HISTORIC AND DESIGN REVIEW COMMISSION

HDRC CASE NO: 2020-253
ADDRESS: 337 W COMMERCE ST
LEGAL DESCRIPTION: NCB 105 BLK LOT 8, W IRR 176.70FT OF E IRR 234.54 OF 5, E IRR 103 OF 6 & E IRR 107.48 FT OF 7
ZONING: D, H, RIO-7B
CITY COUNCIL DIST.: 1
APPLICANT: Russell Williams
OWNER: James Lifshutz/BERLTEX REAL ESTATE HOLDINGS INC
TYPE OF WORK: Exterior modifications, rehabilitation, installation of a canopy
APPLICATION RECEIVED: June 12, 2020
60-DAY REVIEW: Not applicable due to City Council Emergency Orders
CASE MANAGER: Edward Hall

Historic and Design Review Commission
Design Review Committee Report

KLINE'S CLOTHING STORE BUILDING PHOTO - CIRCA 1960's

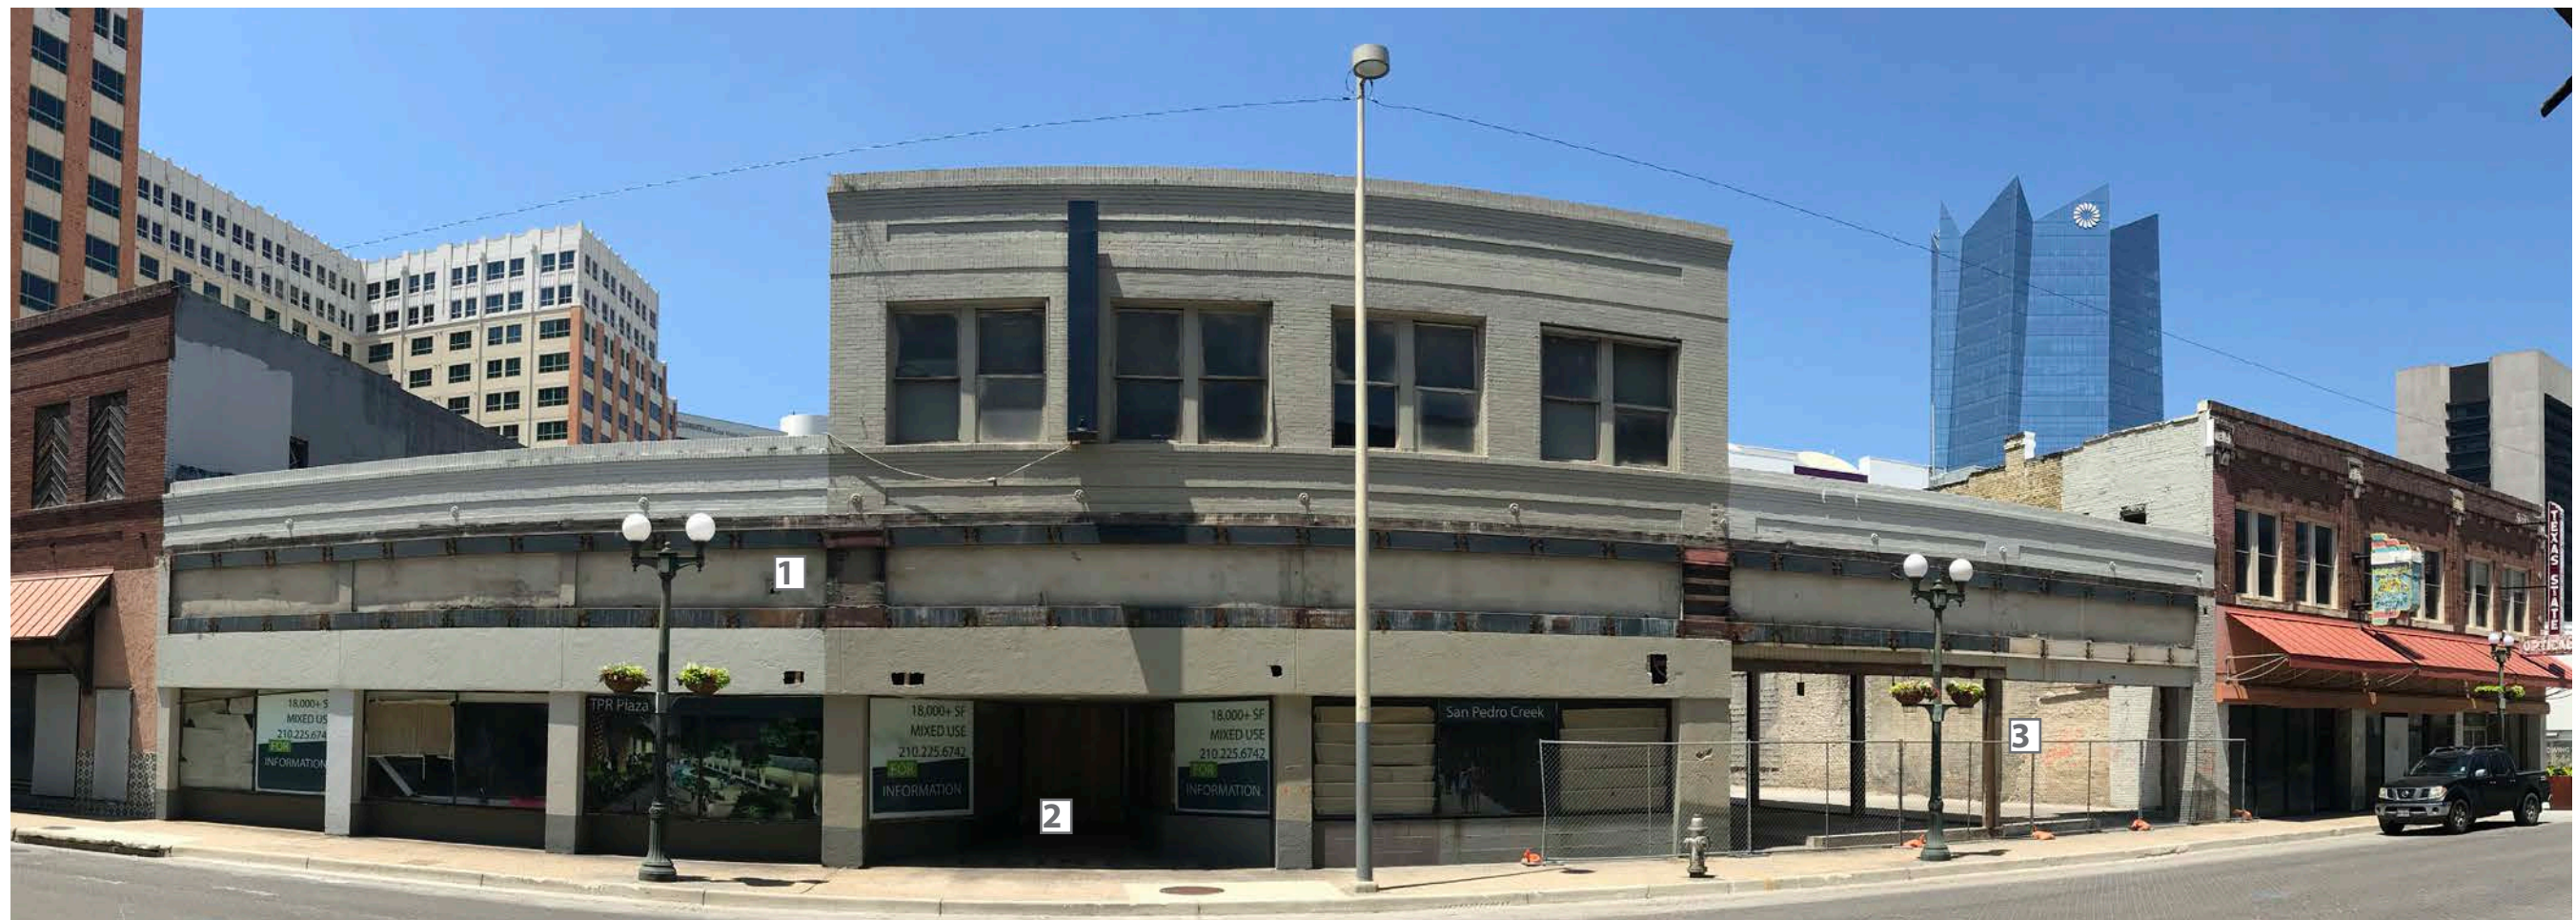
based on the architectural style of the building and be proportionate in shape and size to the scale of the building façade to which they will be attached. Staff finds that the proposed canopy should match the profile of that found in the photograph from the 1960's, which is included in the application documents. The proposed canopy should feature metal construction, as typical for historic canopies. The proposed wood soffits are not consistent with the Guidelines.

- i. That the proposed paint be a water permeable paint to prevent water from becoming trapped between the paint and the brick face.
- ii. That the stucco application feature a smooth finish.
- iii. That the applicant submit details for the proposed storefront system and transom windows, including detailed and dimensioned elevation drawings, and that mullions feature an appropriate width.
- iv. That the proposed canopy feature a profile consistent with that found in the 1960's photograph, and that the wood soffit be eliminated and metal be used instead.
- v. ARCHAEOLOGY – The project shall comply with all federal, state, and local laws, rules, and regulations regarding archaeology, as applicable.

COMMERCE ST. ELEVATION

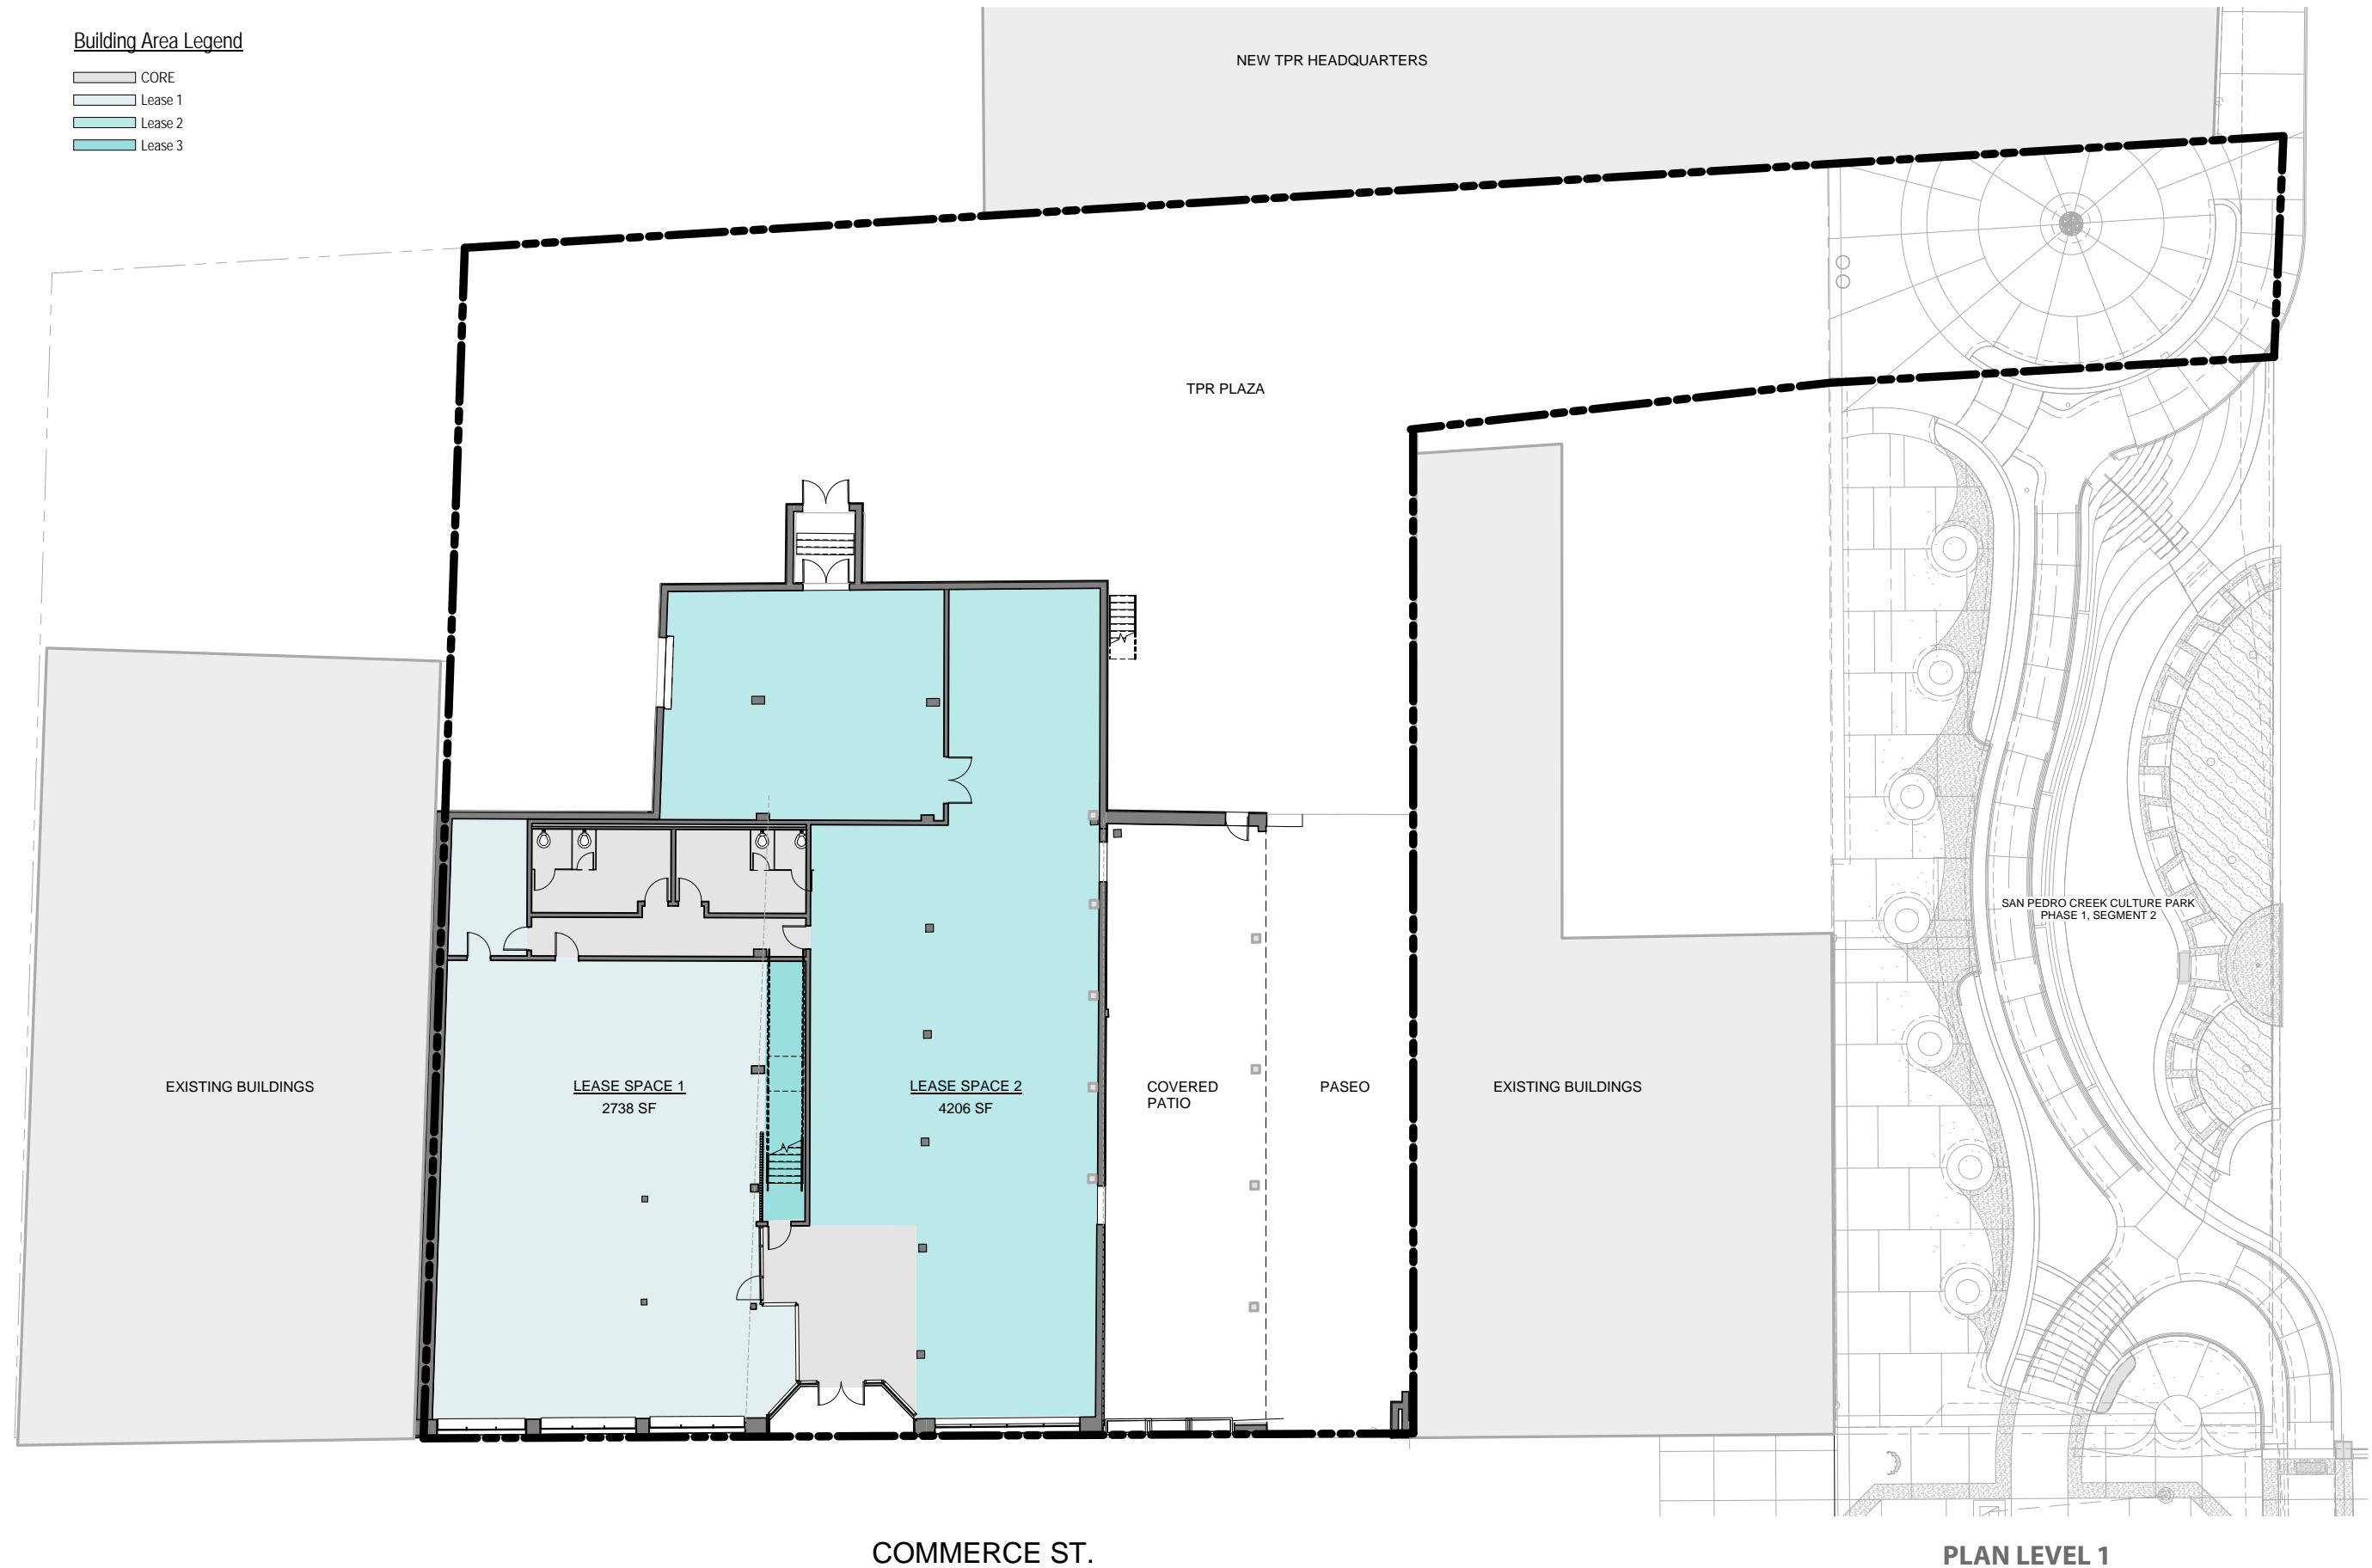
- d. EXTERIOR MODIFICATIONS – The applicant has proposed exterior modifications to include painting, and façade repair. The existing façade features brick above the canopy line that is painted. Below the canopy line, the façade features a number of materials, including wood, plywood, stucco and concrete infill. The applicant has proposed to remove these inappropriate repairs and structurally repair the façade. Staff finds this to be appropriate, and finds the stucco application below the canopy to be appropriate as well. Paint should be water permeable to prevent the trapping of moisture on the brick face.

- f. STOREFRONT SYSTEM – The applicant has proposed to replace the existing, non-original storefront system with a new aluminum storefront system. The Guidelines for Exterior Maintenance and Alterations 10.B. notes that new façade elements that alter or destroy the historic building character, such as inappropriate materials should not be added. Additionally, the Guidelines note that non-historic facades should be returned to their original design based on photographs. If photographs of the original are not available, the scale, design, materials, color and texture of the proposed modifications should be compatible with the historic building. While the original storefront would have featured wood framing, staff finds the proposed aluminum storefront to be an appropriate replacement, given that its an in-kind replacement to the existing. Staff finds that the applicant should submit details for the proposed system, including detailed and dimensioned elevation drawings, and that mullions should feature an appropriate width.

- g. TRANSOM WINDOWS – The applicant has proposed to install transom windows in the existing transom window openings. The applicant has noted that the proposed transom windows will feature aluminum frames. Generally, staff finds the proposed installation to be appropriate. Staff finds that the applicant should submit details for the proposed system, including detailed and dimensioned elevation drawings, and that mullions should feature an appropriate width.
